Recall Notice Service Bulletin 090180 Rev. A

Applicable for All BraunAbility Rear Entry
Conversions Manufactured 1-6-2025 through
5-29-2025

NHTSA Recall No.: 25V381

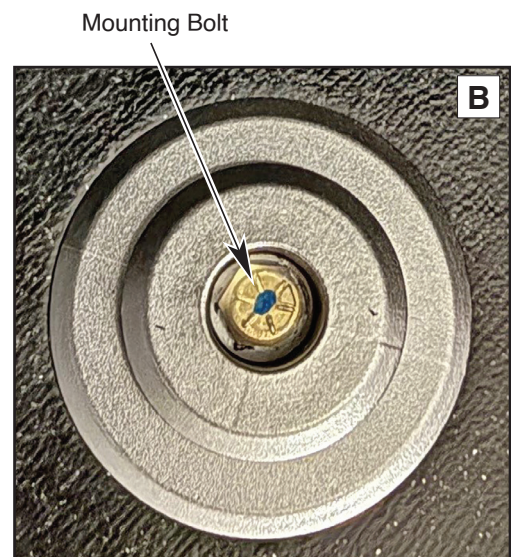
1. Using pick, remove plastic cover from tie
down. See Photo A.

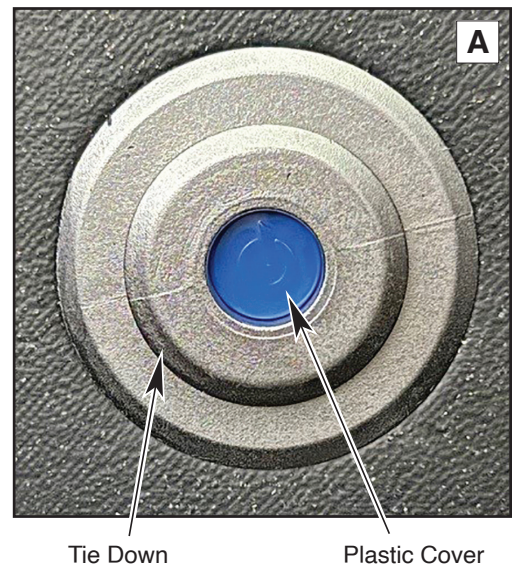
2. Remove mounting bolt from tie down.
See Photo B.

3. Inspect bolt threads for damage:

- If bolt threads are damaged, contact BraunAbility Customer Care and Aftersales.
- If bolts threads are not damaged proceed to Step 4.

4. Install tie down mounting bolt. Torque to 35
ft•lbs.

Note: Do not apply threadlocker.

Electric Retractors

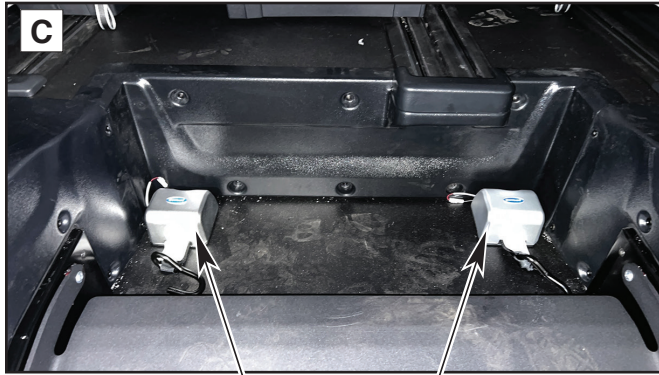
6. Remove electric retractor mounting bolt.

7. Inspect bolt threads for damage:

- If bolt threads are damaged, contact BraunAbility Customer Care and Aftersales.
- If bolts threads are not damaged install bolt. Torque to 35 ft•lbs.

Note: Do not apply threadlocker.
